**Brisbane CBD BUG submission on Woolloongabba PDA development scheme**

This submission provides the views of the Brisbane Central Business District Bicycle User Group (CBD BUG) on the proposed planning framework for the Woolloongabba PDA, which is detailed in A Proposed Development Scheme, called The Woolloongabba Plan and Draft Public Realm Guideline.

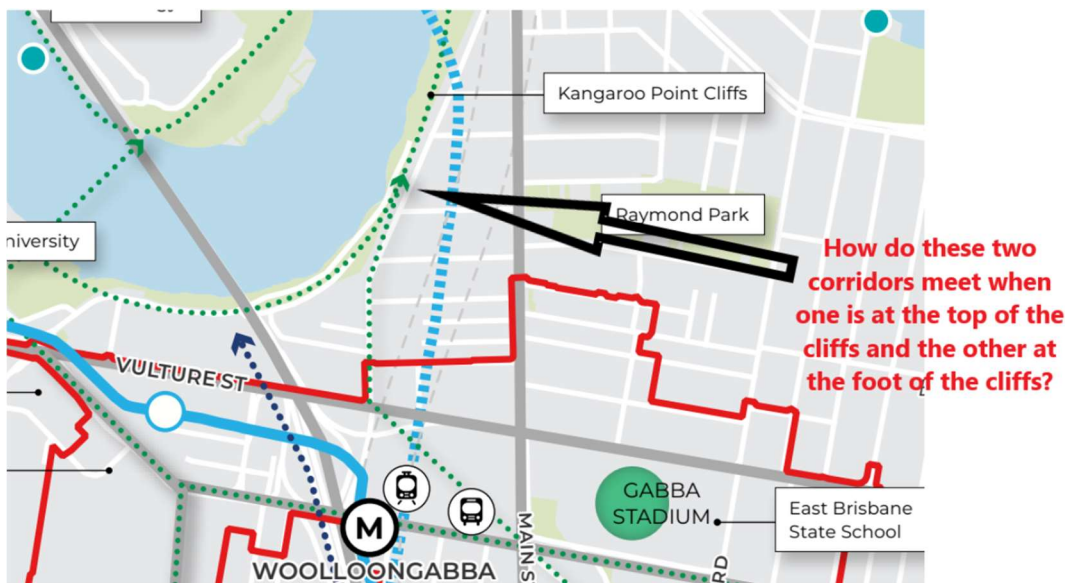
The “Creek to Cliffs Green Corridor” is a very commendable concept. However, at its northern end it is very difficult to understand how this will link to the existing path along the foot of the Kangaroo Point Cliffs given the significant differences in grade/elevation (refer following image). The only existing street that directly connects Leopard St to the path at the foot of the Kangaroo Point cliffs is Ellis St, which is narrow and has an extremely steep grade, such that is unrideable for many people traveling by bicycle and unfriendly for people walking. The stairs and ramp linking the cliff tops to Lower River Terrace can be used by some pedestrians – but are steep and narrow and from a bygone era.
